RIVERBEND CROSSING
FILING NO. 1
STREET, STORM, & STRIPING
CONSTRUCTION DRAWINGS

STREET IMPROVEMENT, STORM SEWER, AND SIGNAGE & STRIPING CONSTRUCTION DRAWINGS

PCD FILE #: SF-18-044

SOUTHMOOR DRIVE WIDENING DETAIL - URBAN RESIDENTIAL COLLECTOR
SCALE: N.T.S.

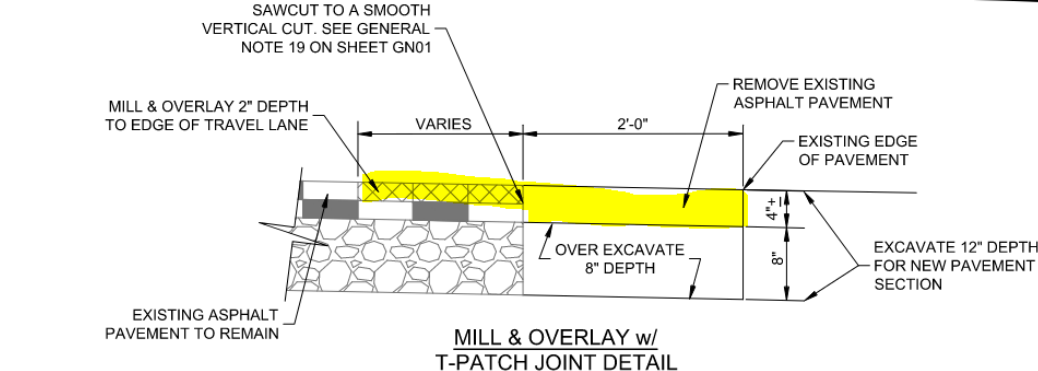
Provide sawcut construction detail. Plan view to show extent of
mill/overlay. There needs to be a t-cap versus a straight vertical edge
between the existing asphalt and new asphalt (see example detail below).

RIVERBEND CROSSING FILING NO. 1 SOUTHMOOR DRIVE STREET IMPROVEMENT PLAN	DESIGNED BY: MGP SCALE: 1" = 50' JOB NUMBER: 17-114	DRAWN BY: MGP DATE: 02/10/20 SHEET: 2 OF 17
--	---	---

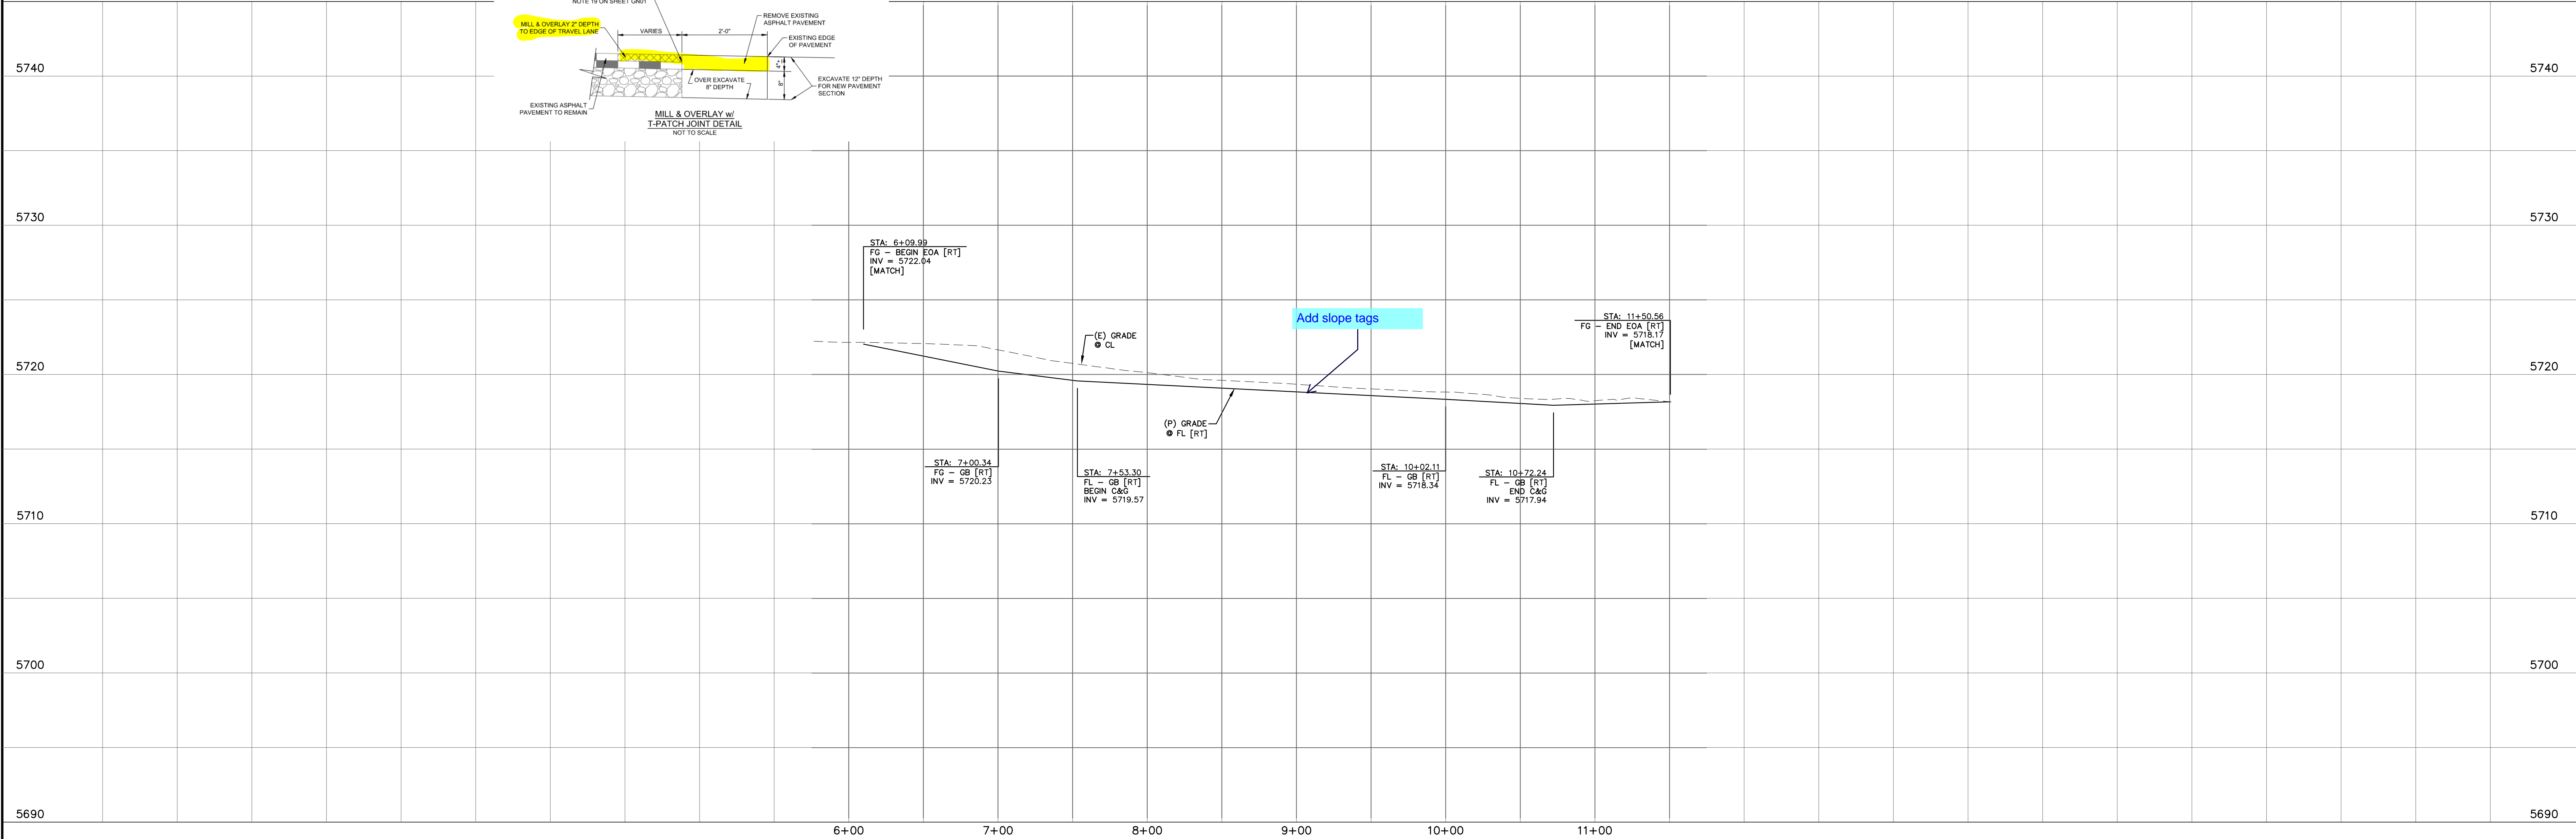
Street construction plans for Southmoor Drive related to the commercial development requires County review/approval.

Provide the street alignment bearing information. Survey info missing to tie in the alignment to realworld coordinate.

Extend proposed sidewalk to the edge of property line.

provide alignment curve data. Provide station equation to Booker Blvd centerline alignment.

Adjust to a smoother transition. Per the typical cross section on sheet 1 this should be C&G. If not, then provide a second typical cross section detail and identify the station range where each section detail applies. Per the TIS, recommended transition section in order to incorporate specific striping appears to start at 12+00.

Adjust sidewalk alignment. Modify manhole rim to match proposed sidewalk.

Provide sawcut construction detail. Plan view to show extent of mill/overlay. There needs to be a t-cap versus a straight vertical edge between the existing asphalt and new asphalt (see example detail below).

PETER CIRCLE - LOCAL
STA: 1+00 ~ 3+00

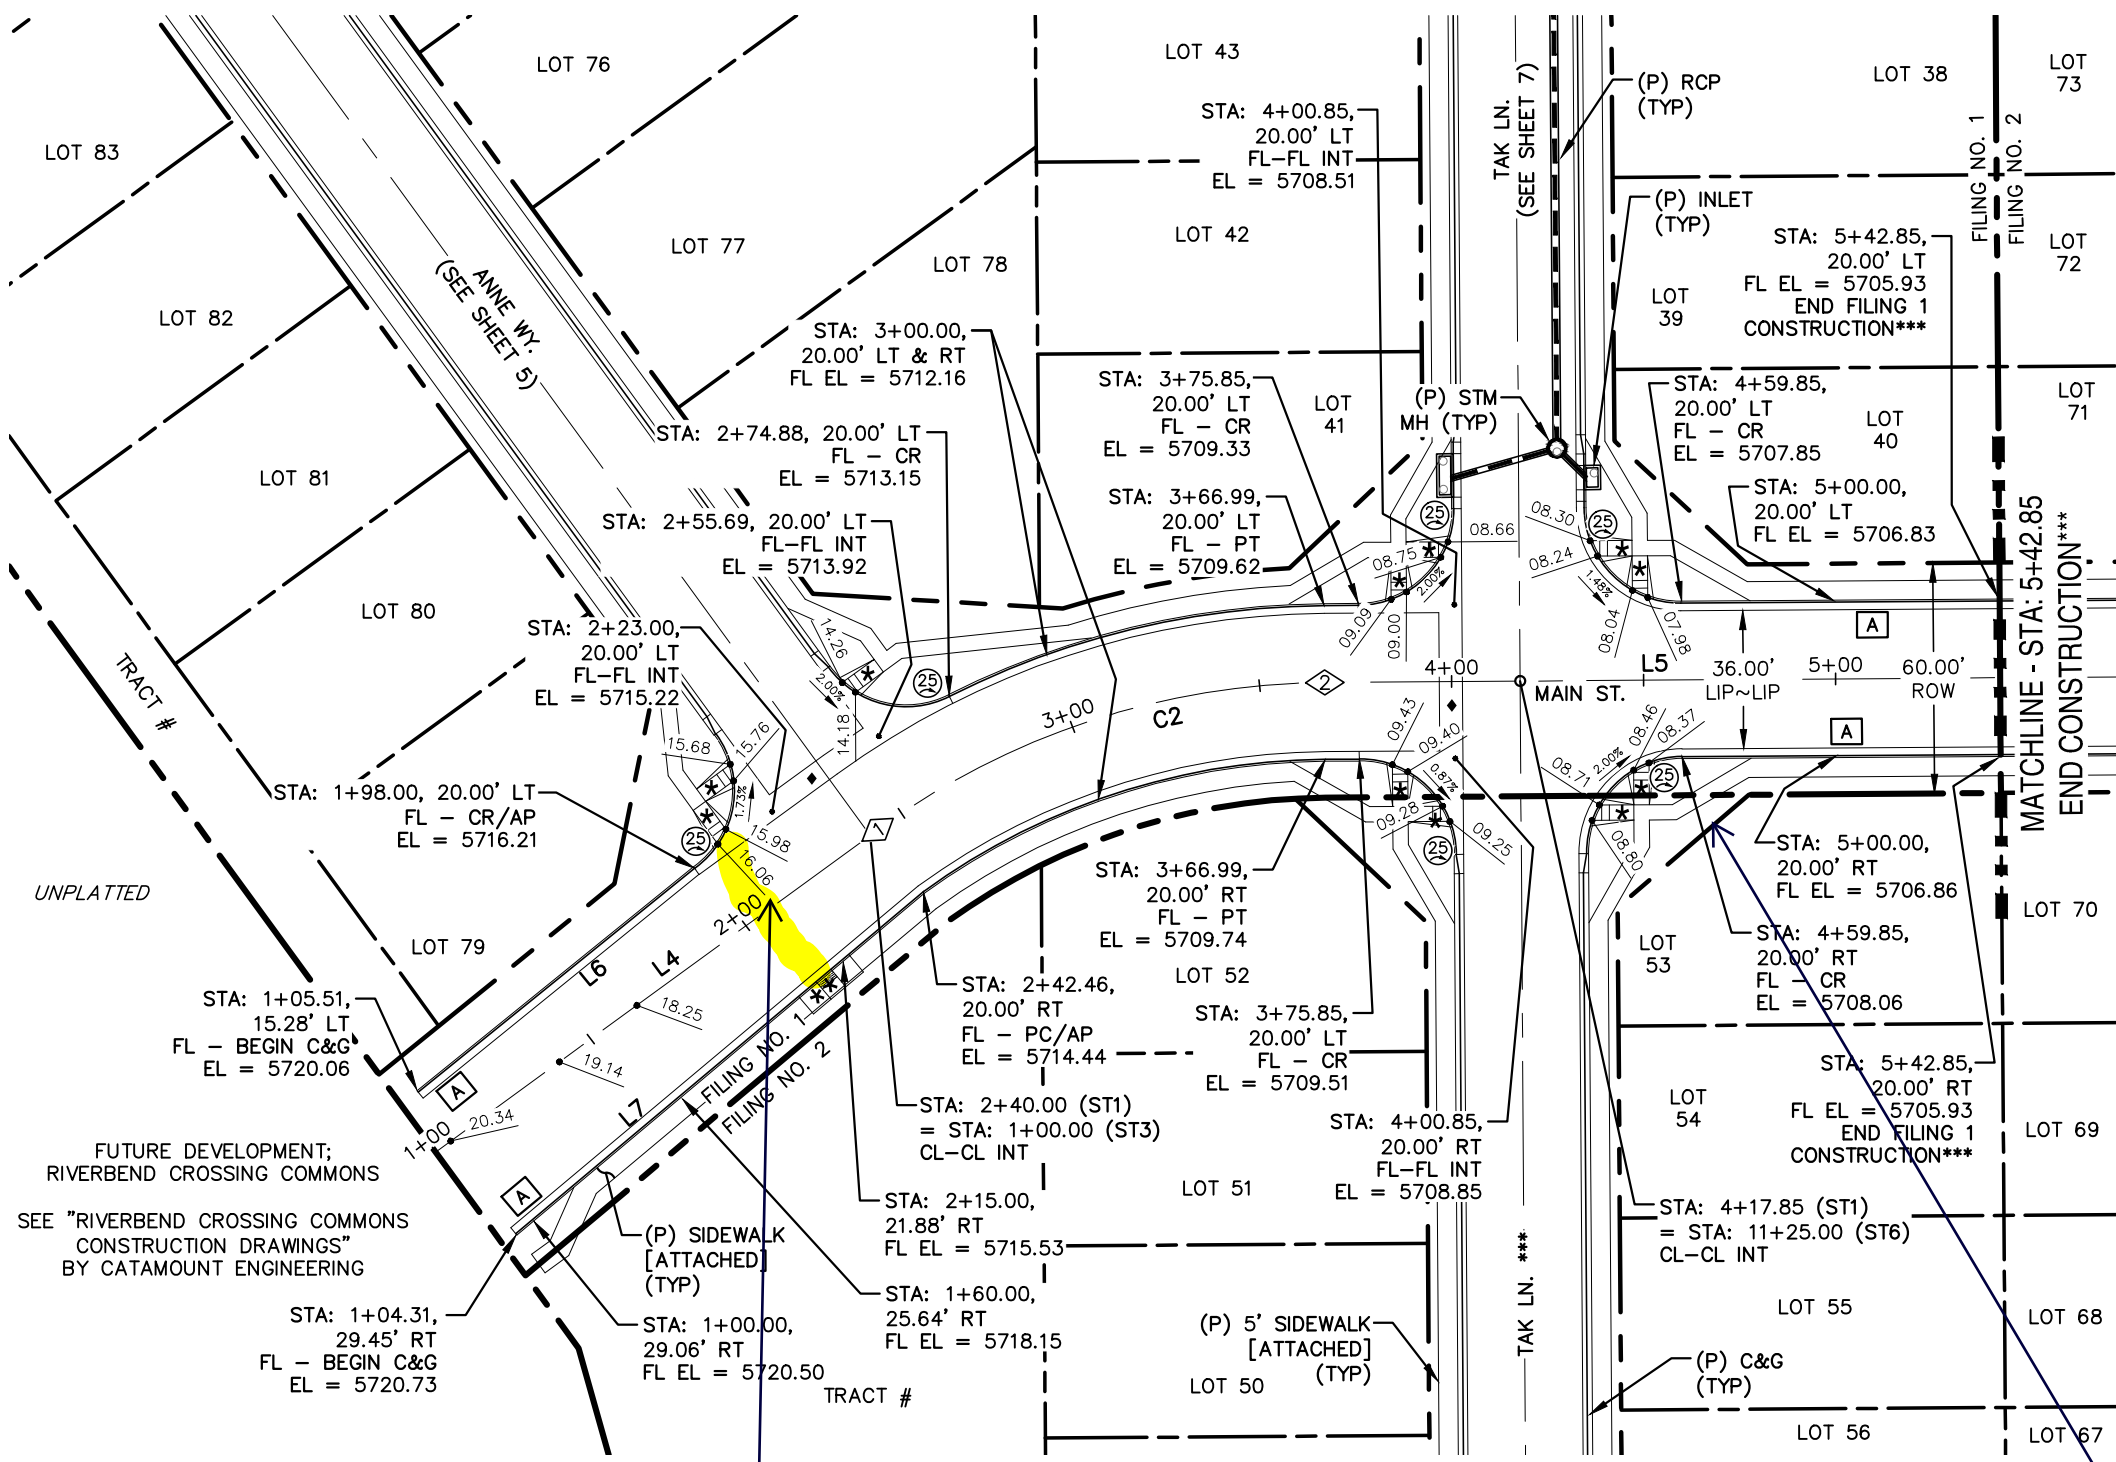
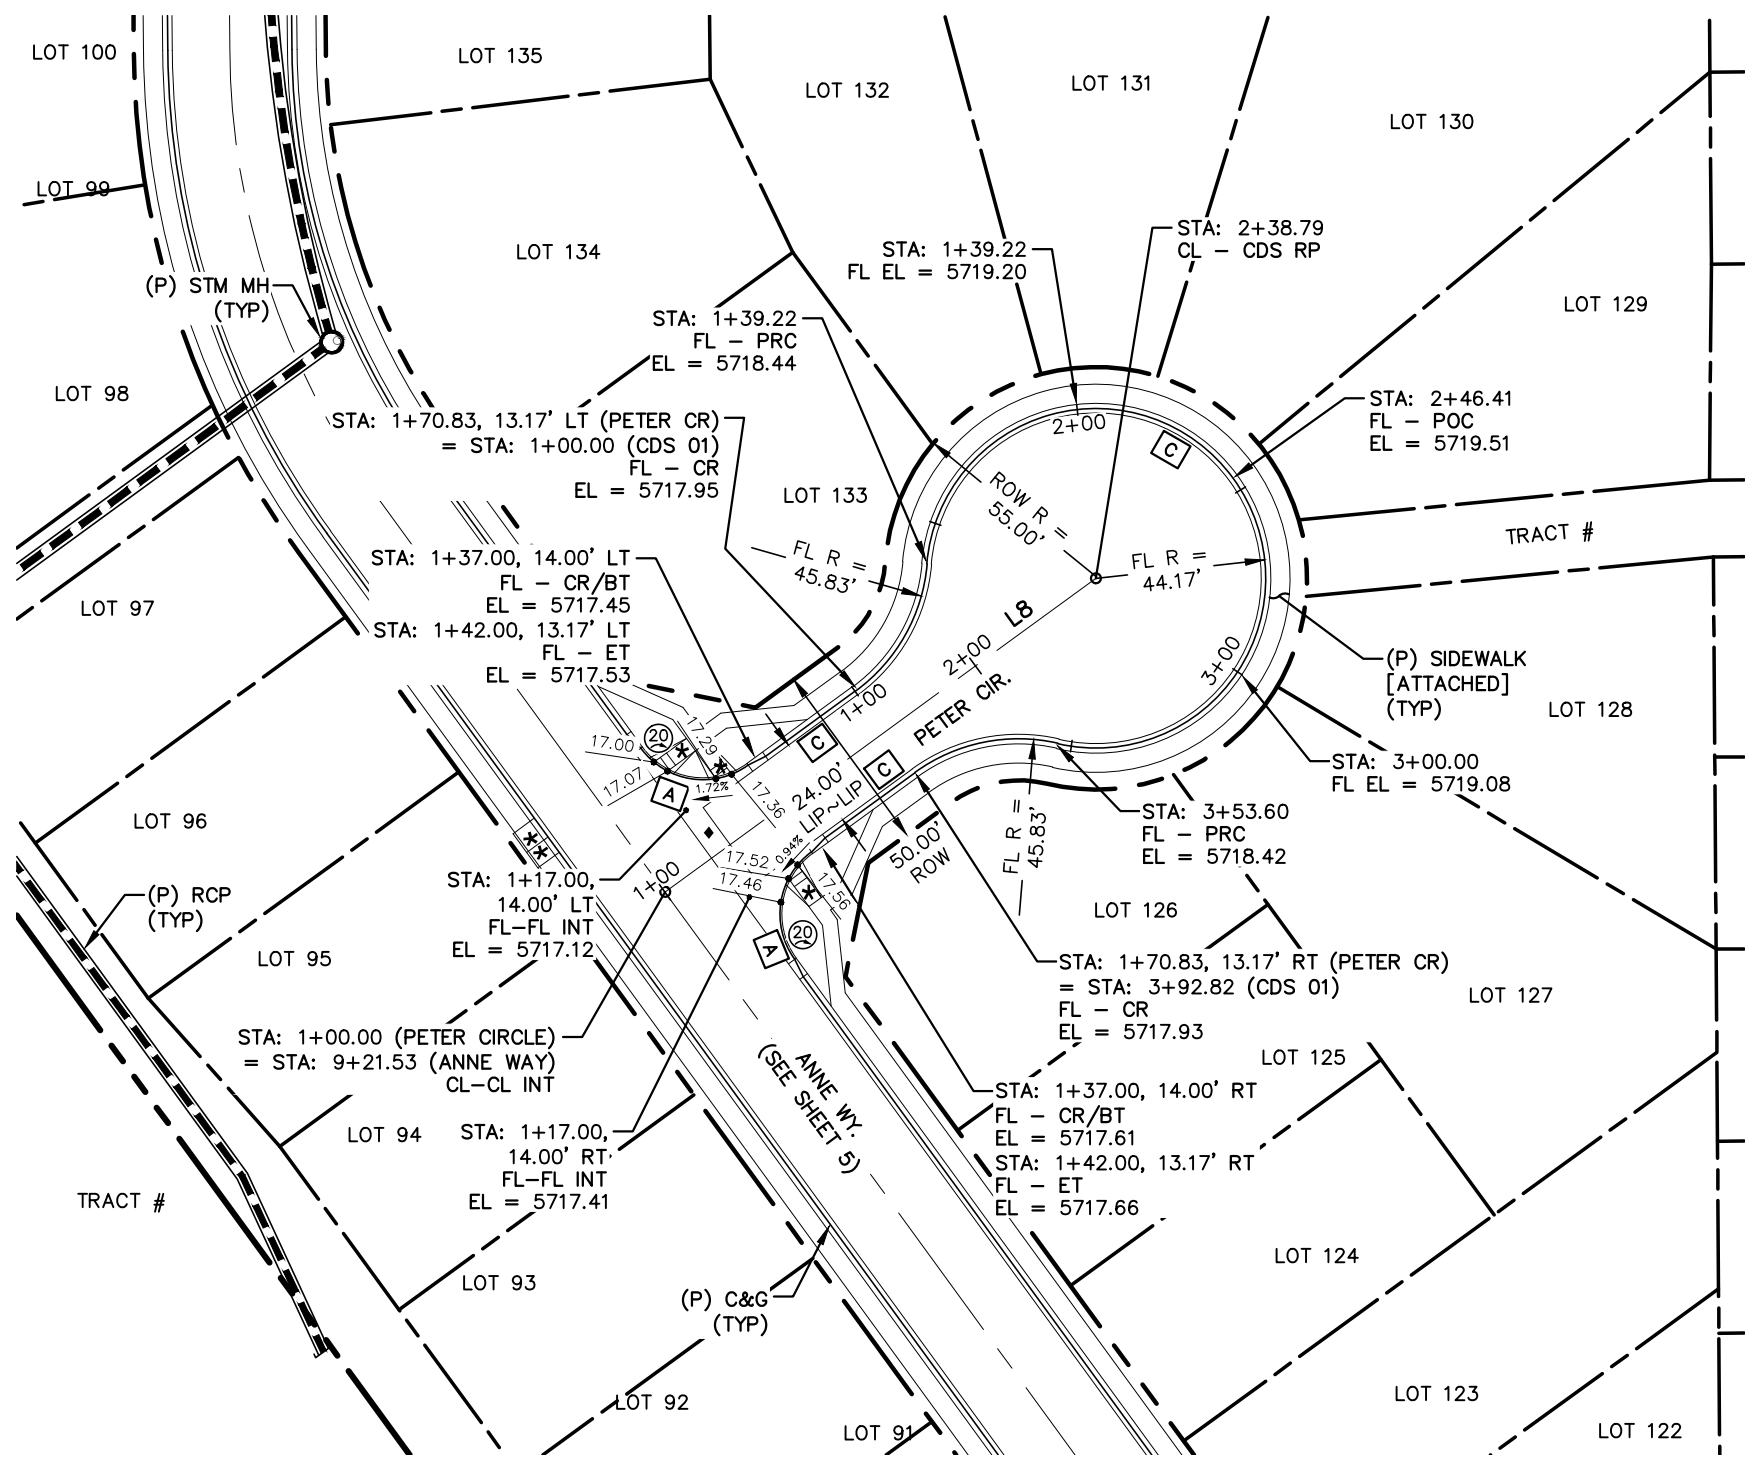
Double check and make sure the roadway grade (ADA path cross slope) is 5% max.

Provide detailed spot elevations at all ramps. See example to the right from another project. Unresolved.
